## REMARKS

This is intended as a full and complete response to the Office Action dated July 16, 2004, 2004, having a shortened statutory period for response extended one month set to expire on November 16, 2004. Please reconsider the claims pending in the application for reasons discussed below.

FIG. 3

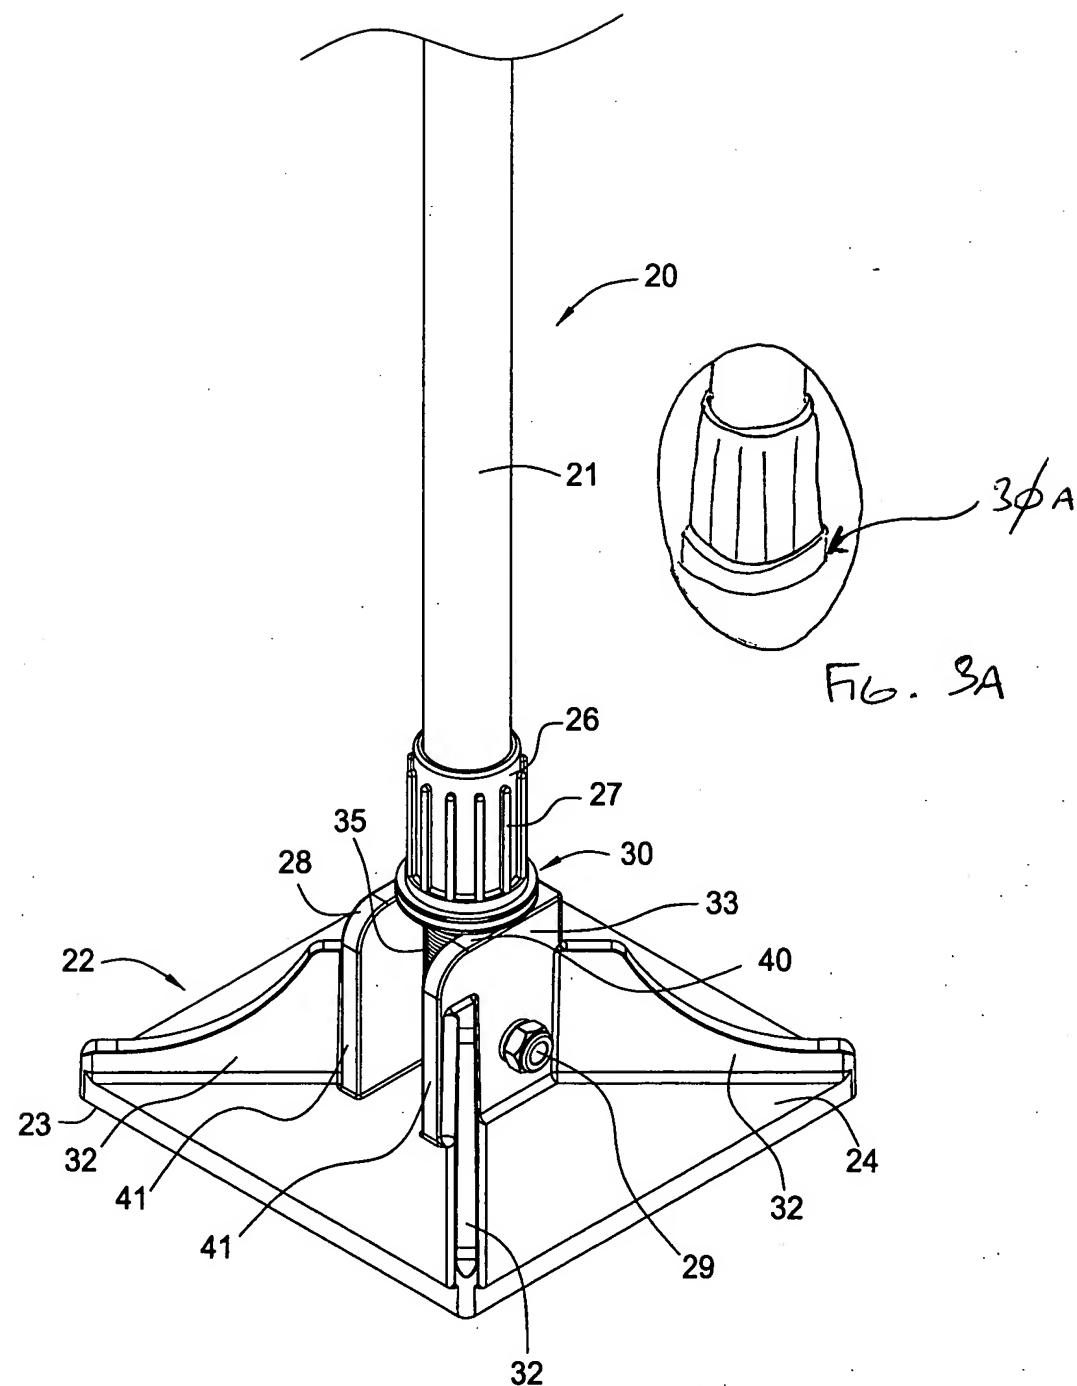
Applicants have amended the drawings in response to the Examiner's comments. No new matter has been added, however. FIG. 8 has been amended to correct the reference number related error specified by the Examiner. In addition FIG. 3A has been added to sheet 3/8 to further clarify aspects of the invention and to respond to the Examiner's comments.

Please replace sheets 3/8 and 8/8 with the attached sheets containing figures 3, 3A and amended figure 8.
